International Aero Engines

V2500-A1 PROPULSION SYSTEMS SERVICE BULLETIN

This document transmits Revision 1 to Service Bulletin EV2500-71-0110

ENGINE – PROVIDE REROUTED OIL TUBES FOR THE ACOC AND THE OIL TANK ASSEMBLY

Pressure Oil Tubes and Tube Clipping Details - Before Alteration
Figure 1, Sheet 1 of 3

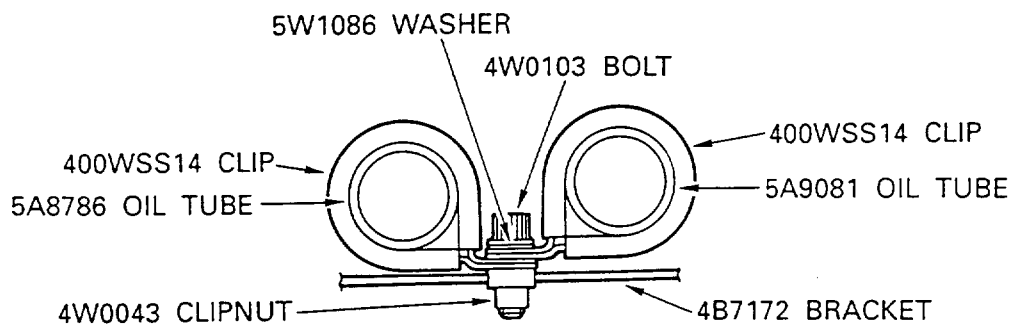
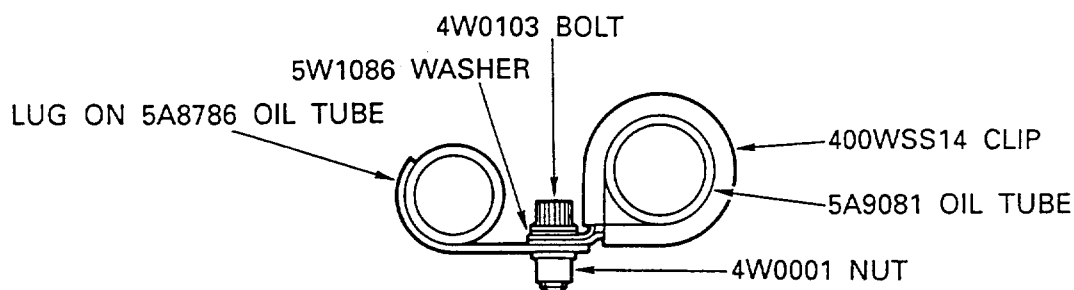
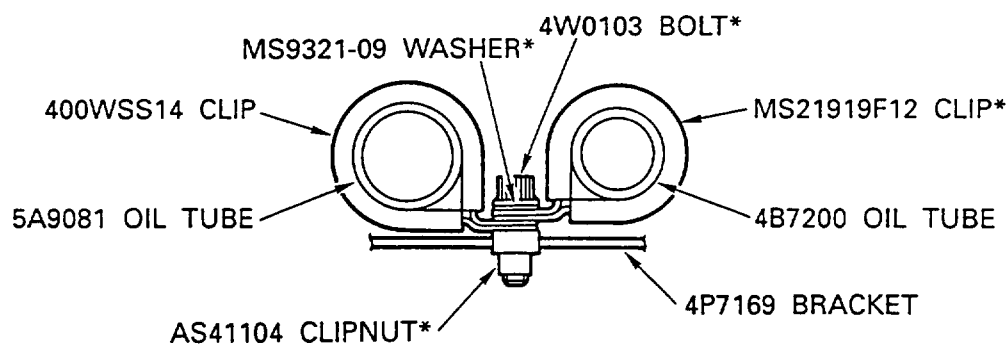
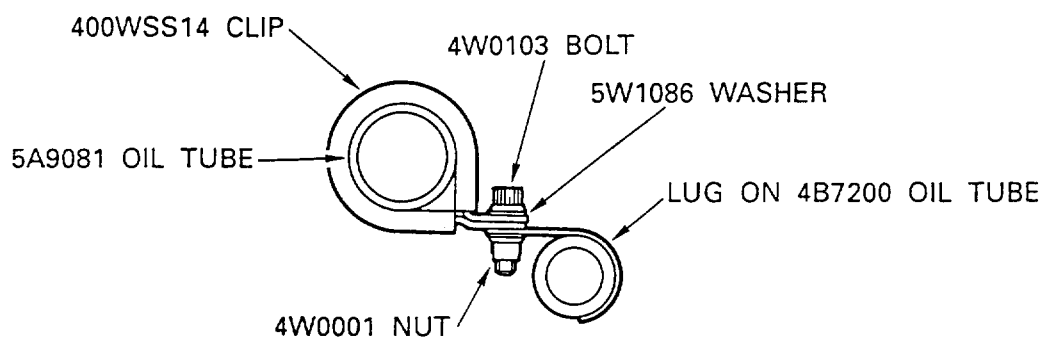
(a) New oil tubes 5A8796, 5A8795, 5A8797 and 4B7263 are introduced in lieu of the existing oil tubes 5A8786, 5A9081, 5A8770 and 4B7200 (See Figures 1 and 6).

(i) The existing clipping positions CP0331, CP0334, CP0333 and CP0318 which are used to hold the oil tubes are deleted (See Figure 1).

Clipping Details of the Electrical Harnesses - Before Alteration
Figure 2, Sheet 1 of 4

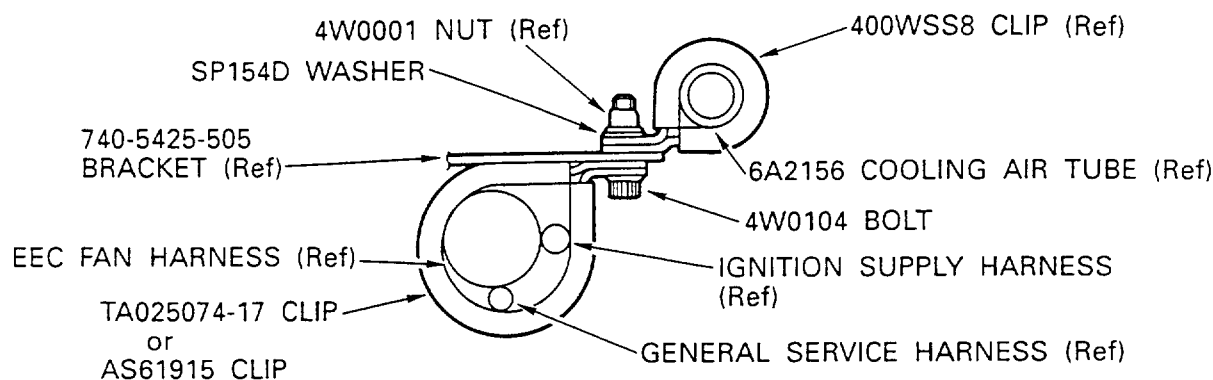
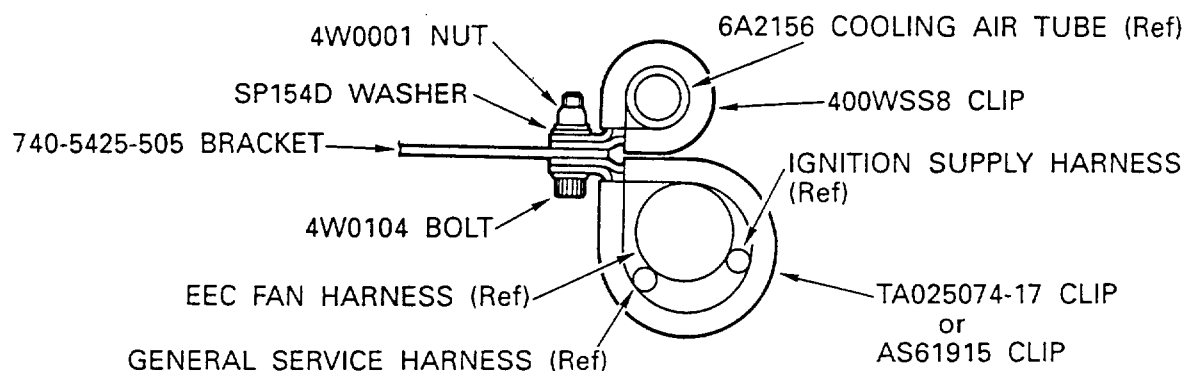
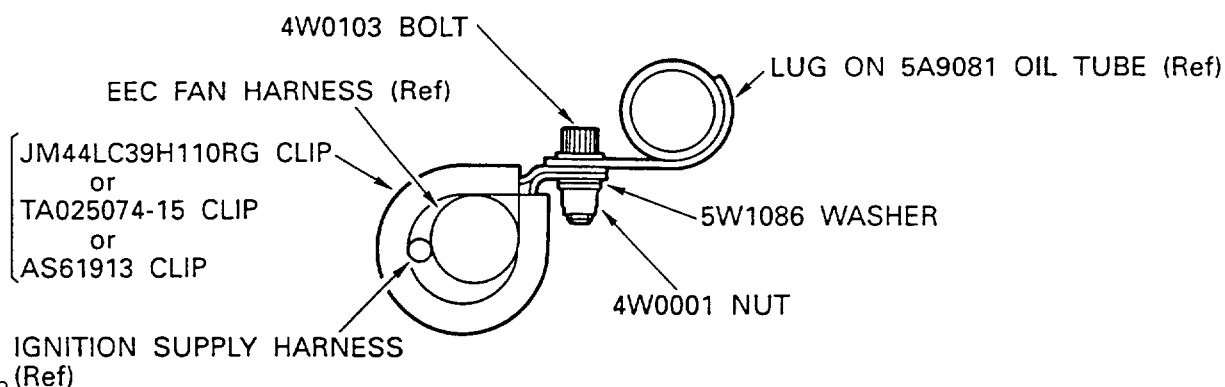
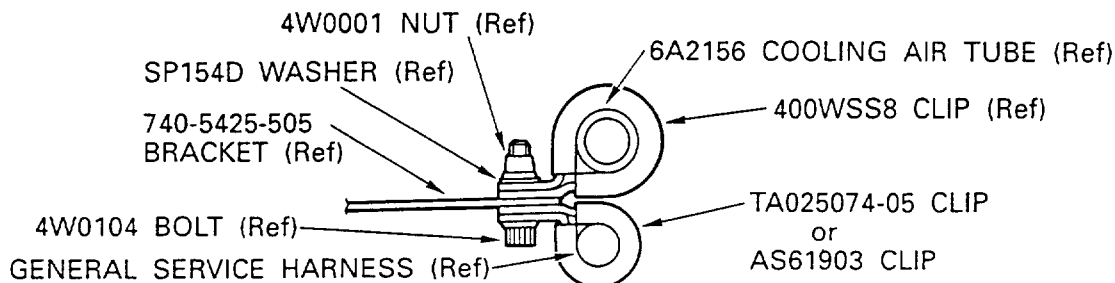
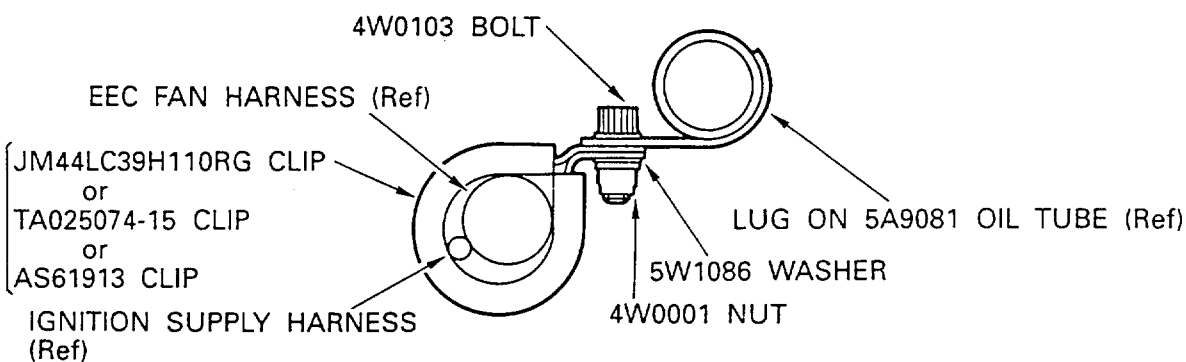
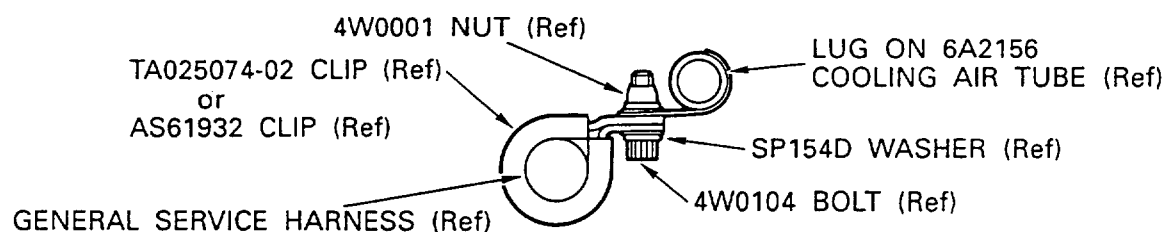
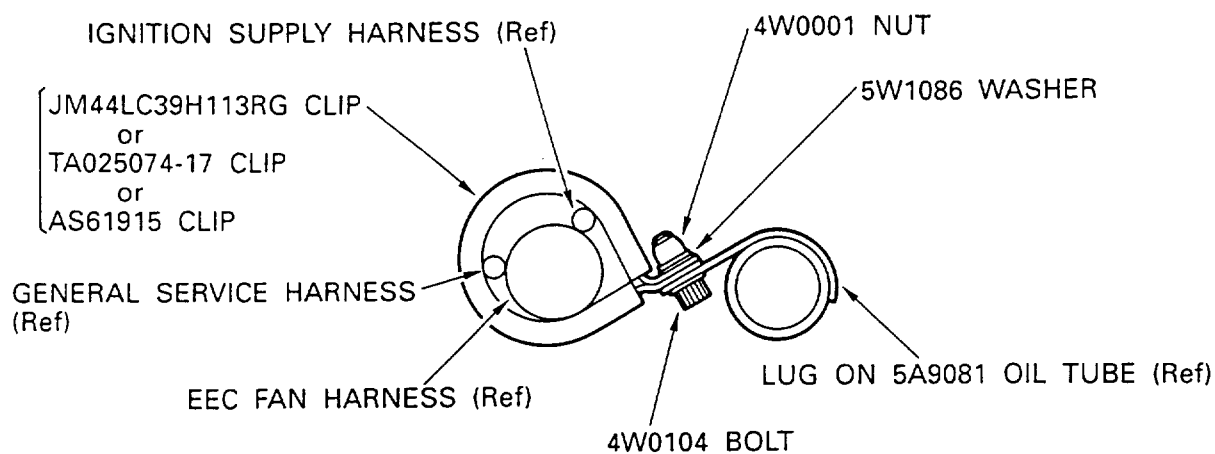
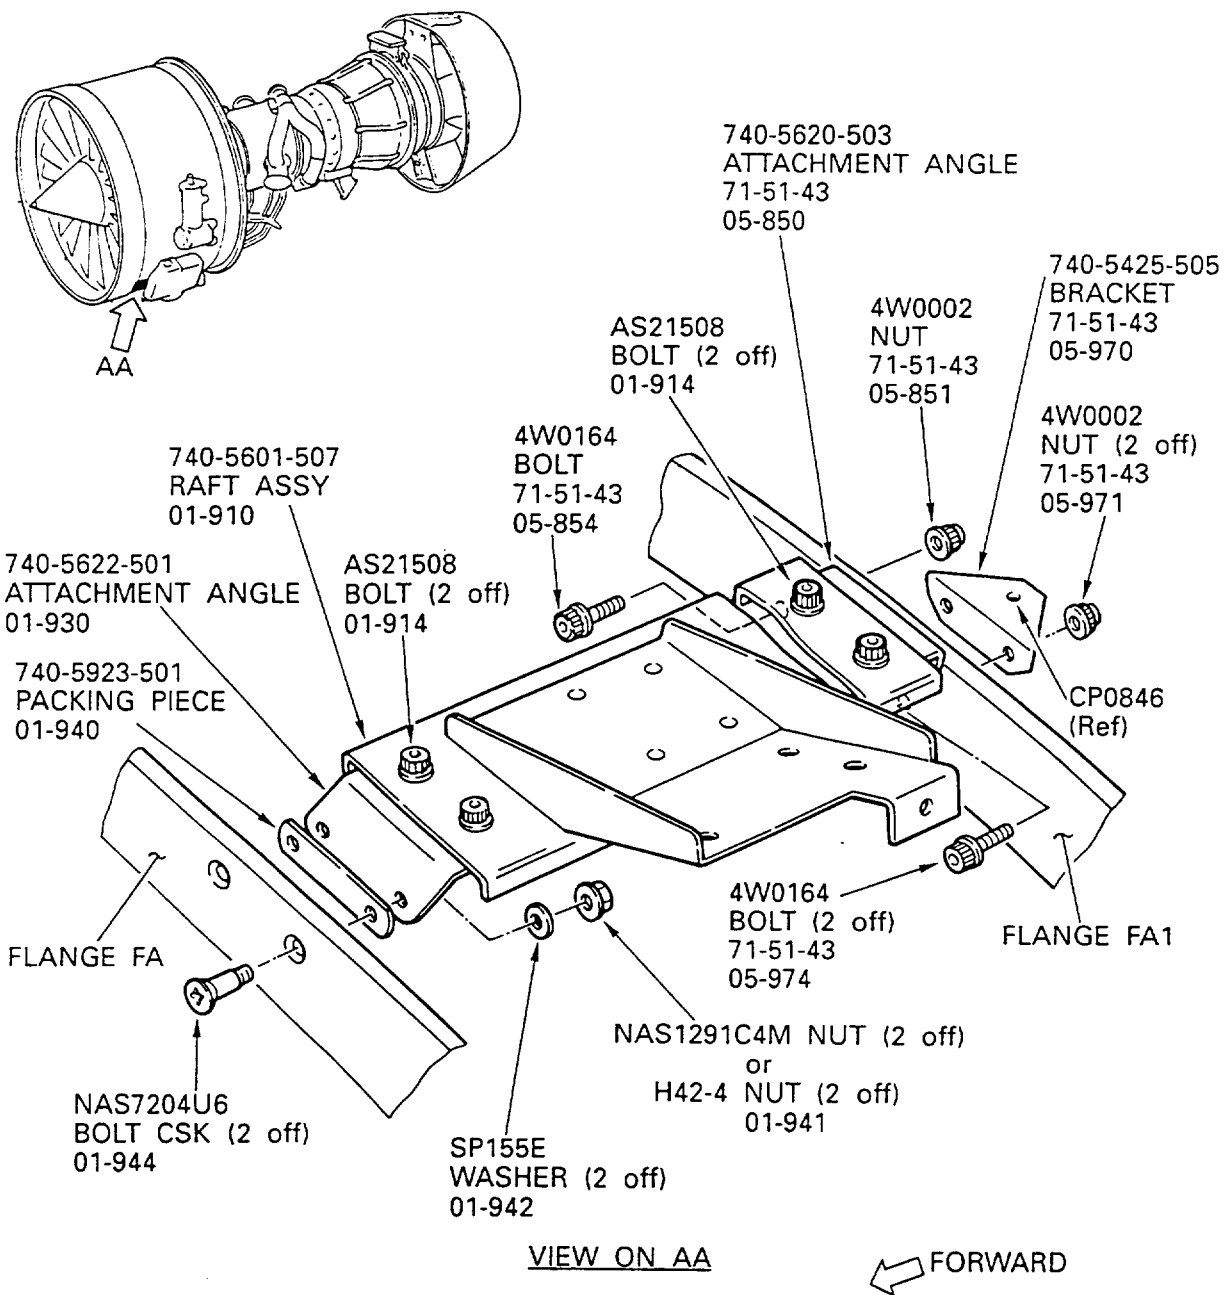
- (v) The existing clipping positions CP0846, CP1019, CP1020 and CP0786 which are used to hold the electrical harnesses are deleted (See Figure 2).
 - (vi) The existing clipping positions CP0845, CP0847 and CP0893 which are used to hold the electrical harnesses are changed to the new clipping configurations (See Figures 2 and 7).

Raft and Brackets - Before Alteration
Figure 3

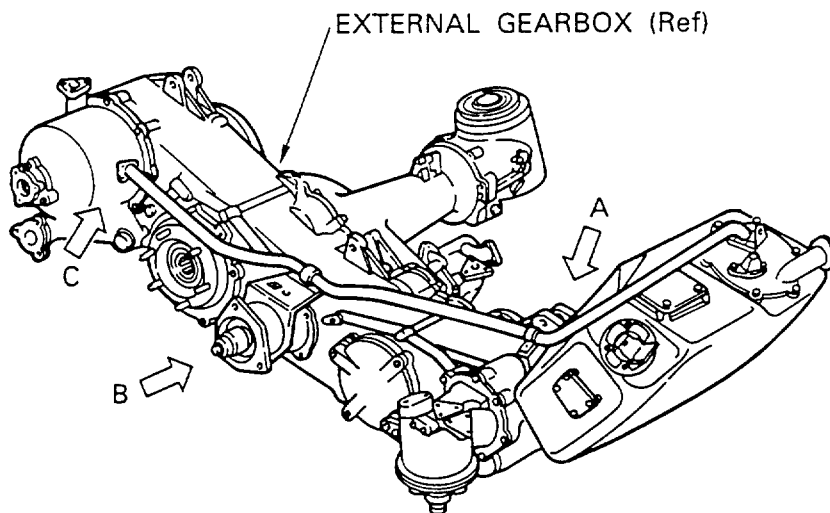
- (vii) The new clipping positions CP1113, CP1112 and CP1106 are introduced to hold the electrical harnesses (See Figure 7).
 - (viii) The existing brackets 740-5425-505 which is used to hold the electrical harnesses at CP0846 is deleted (See Figure 3 and 5).

- (c) The existing catalog sequence numbers of the raft assembly which is used to secure the case drain filter are changed to the new catalog sequence numbers (See Figures 3 and 5).

Location of Brackets on External Gearbox
Figure 4, Sheet 1 of 3

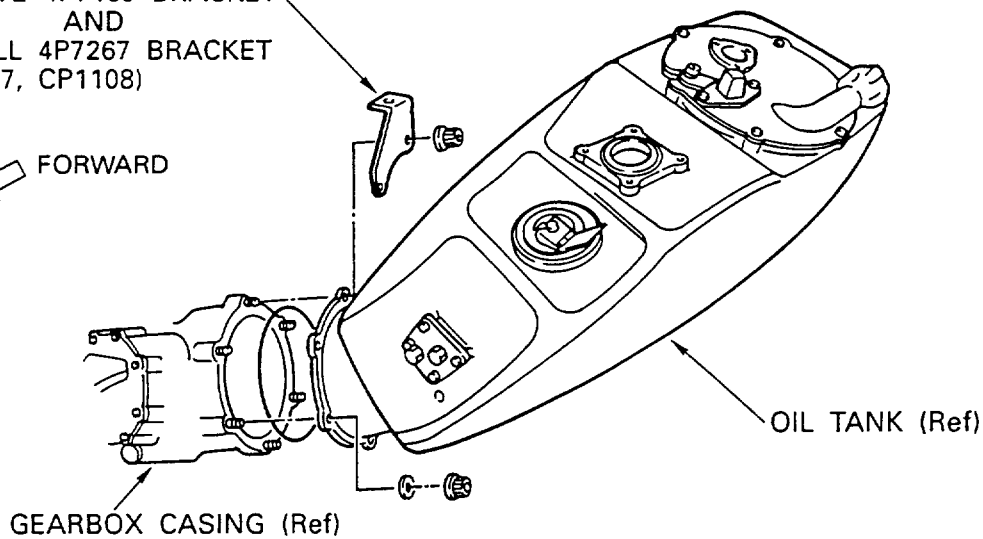
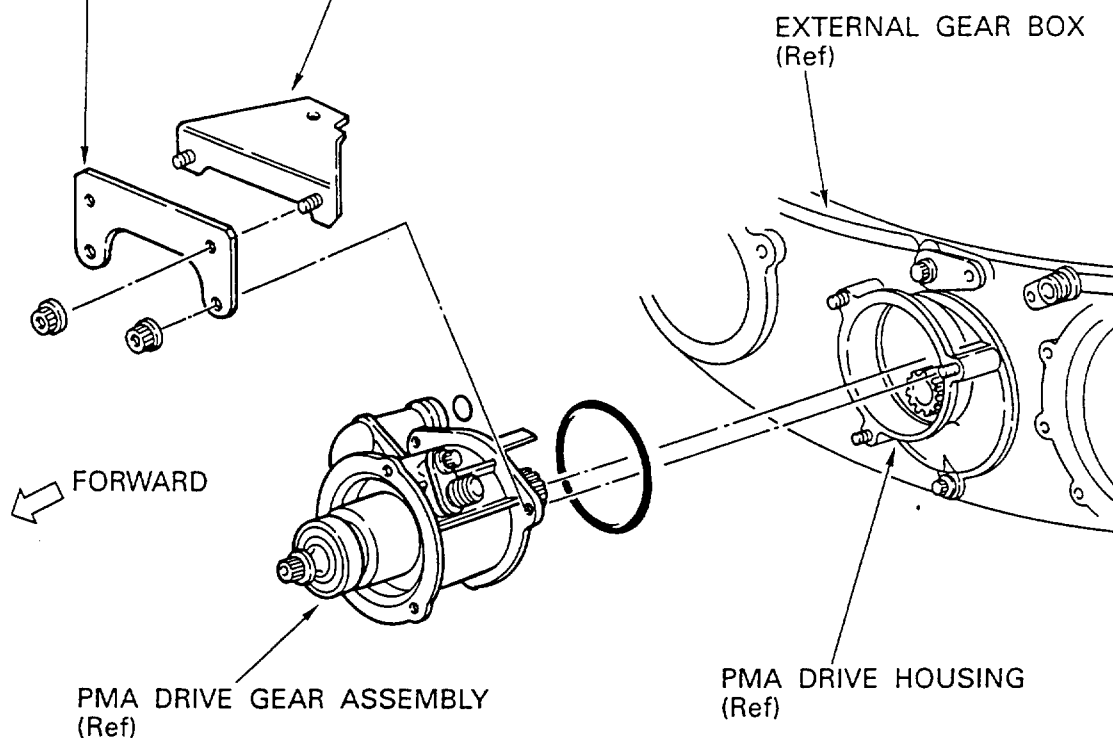
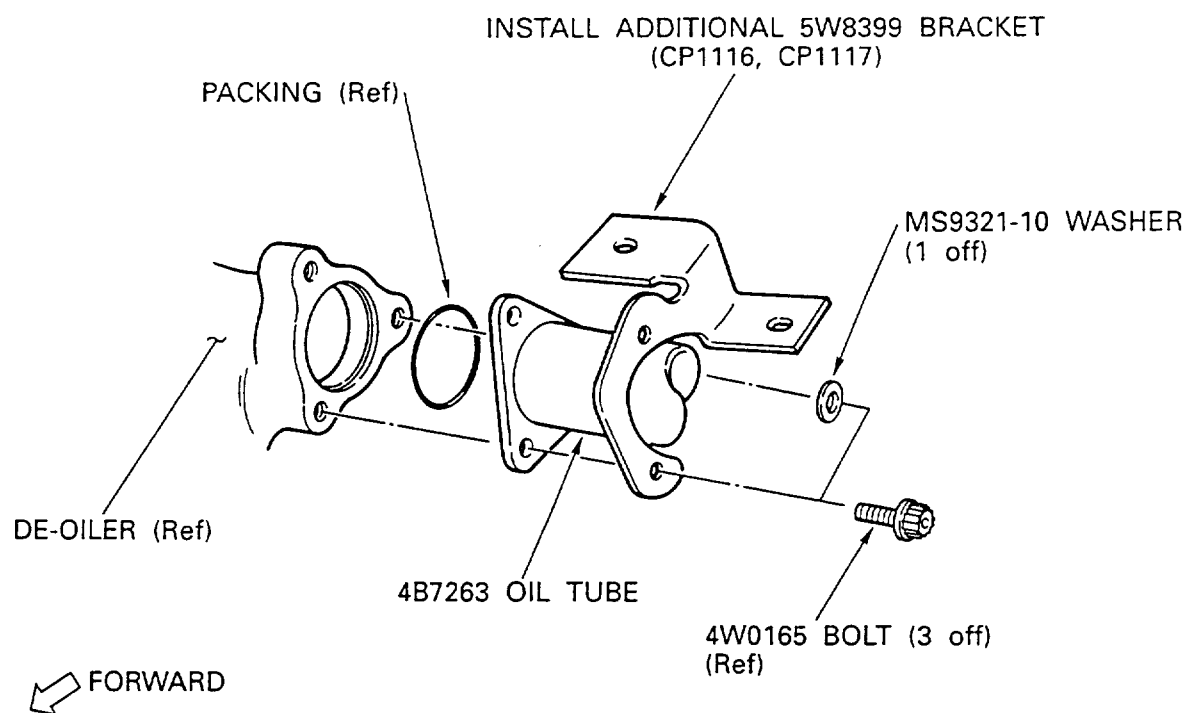
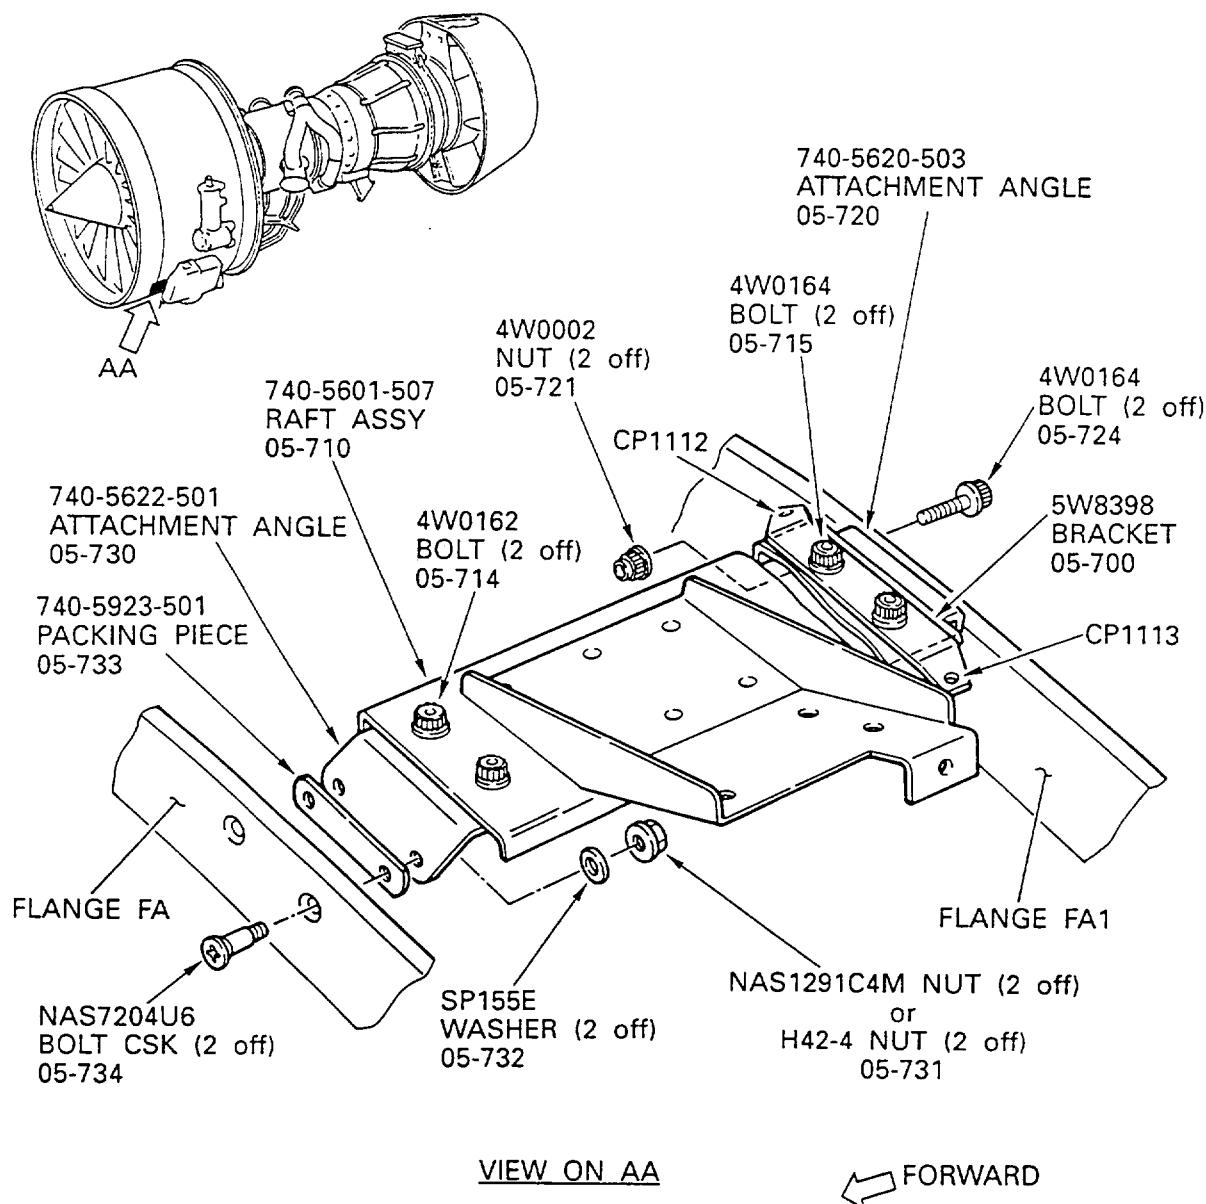
- (iii) The existing brackets 4P7171 and 4B7172 which are used to hold the oil tubes at CP0331 are changed with new brackets 4P7266 and 4B7265 to hold the new oil tubes at CP1110 and CP1111 (See Figure 4).

- (iv) The existing bracket 4P7169 which is used to hold the oil tubes at CP0333 is changed with a new bracket 4P7267 to hold the new oil tubes at CP1108 and CP1107 (See Figure 4).

- (ix) The new bracket 5W8398 is introduced to hold the electrical harnesses at CP1112 and CP1113 (See Figure 5).
 - (x) The new bracket 5W8399 is introduced to hold the oil tubes at CP1116 and CP1117 (See Figure 4, Sheet 3).

REMOVE 4P7169 BRACKET
AND
INSTALL 4P7267 BRACKET
(CP1107, CP1108)

REMOVE 4P7171 BRACKET
AND
INSTALL 4P7266 BRACKET
(CP1110, CP1111)

REMOVE 4B7172 BRACKET
AND
INSTALL 4B7265 BRACKET
(CP1110, CP1111)

- (2) Install the Brackets to the External Gearbox as follows (Refer to Figure 4):
 - (a) Install 4P7267 Bracket to the Oil Tank flange by the approved procedures in the Engine Manual, 72-00-60, Installation, TASK 72-00-60-420-001-002 (Refer to Figure 4, Sheet 1 and 1.K (2)).

- (b) Install 4P7266 Bracket and 4B7265 Bracket Assembly to the PMA Drive Gear mount flange by the approved procedures in the Engine Manual, 72-00-60, Installation, TASK 72-00-60-450-012-A00 (Refer to Figure 4, Sheet 2 and 1.K (2)).

- (c) Together with 5W8399 Bracket, install the three bolts and one washer that attach 4B7263 Oil Tube (Oil Tank Breather Tube) to the De-oiler. Torque the bolts to 85 to 105 lbfin. (10 to 12 Nm) (Refer to Figure 4, Sheet 3).
